Summary of Changes

This summary of changes is a synopsis of the NRC Requests for additional Information (RAI) and the FCS response to those requests. A detailed version of the response can be found in LIC-17-0047 that was submitted to the NRC on May 15, 2017. The NRC approved the Permanently Defueled Emergency Plan (PDEP) based on FCS response to the RAI's on December 12th, 2017 by Amendment No. 295 effective April 7, 2018 and this amendment shall be implemented within 90 days of the effective date. PORC approved the PDEP submitted to the NRC on December 16, 2016 and this summary only covers changes made since that time. NOTE: No changes were made to EP-FC-1001 Addendum 3 other than adding the procedure number to the top of each page. The content of EP-FC-1001 Addendum 3 remains the same as the initial submittal and was previously approved by PORC.

**PERMANENTLY DEFUELED
EMERGENCY PLAN
FOR FORT CALHOUN STATION**

FIGURE 2.1

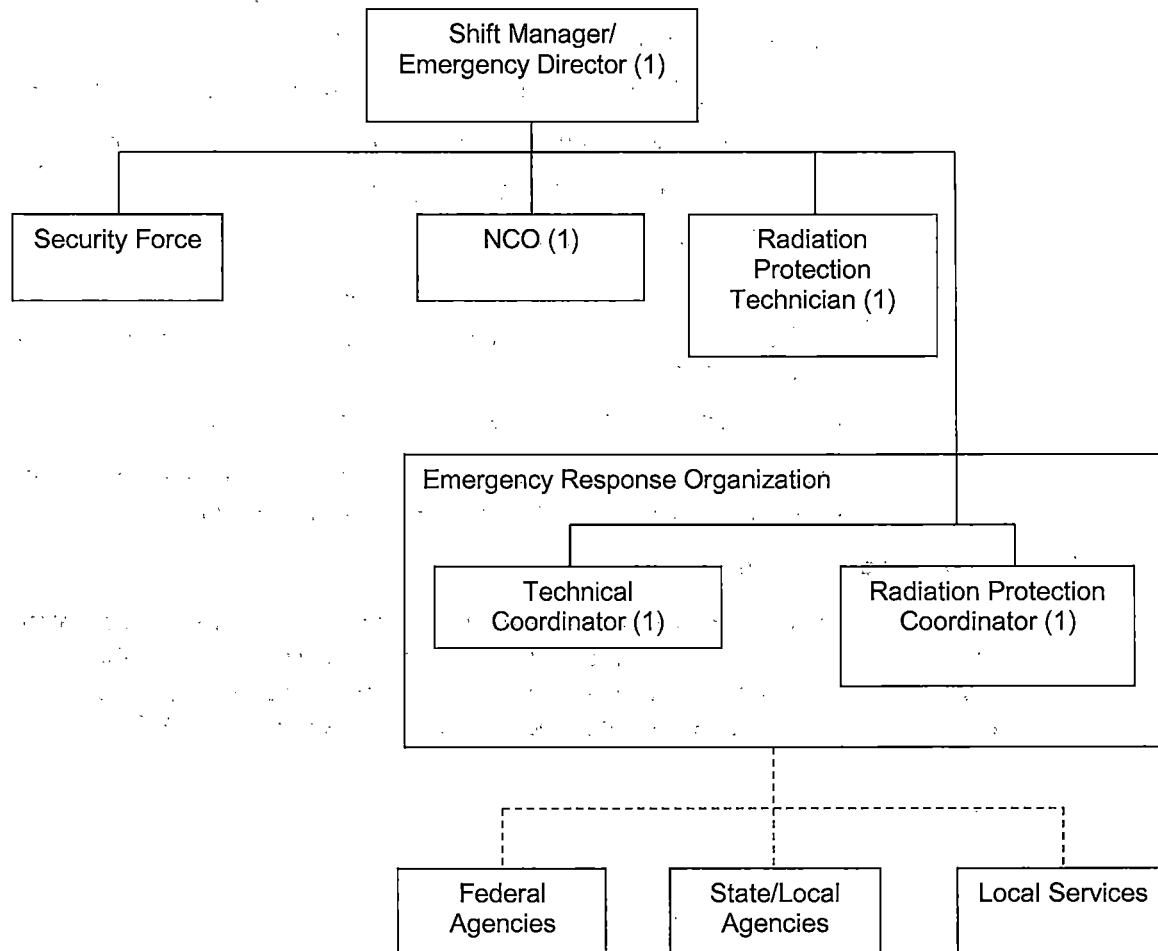
(NRC) FCS-RAI-5 – There is no reference to any personnel specifically assigned to perform SFP inventory makeup strategies in the proposed PDEP. Please explain who performs SFP inventory makeup strategies.

FCS Response: Table 2.1, “On-Shift and Emergency Response Organization Staffing Requirements,” includes an “*” next to the Non-Certified Operator (NCO), Shift Manager (SM), and the on-shift Radiation Protection Technician indicating these positions are on-shift personnel required to direct or perform site-specific mitigation strategies required for a catastrophic loss of SFP inventory.
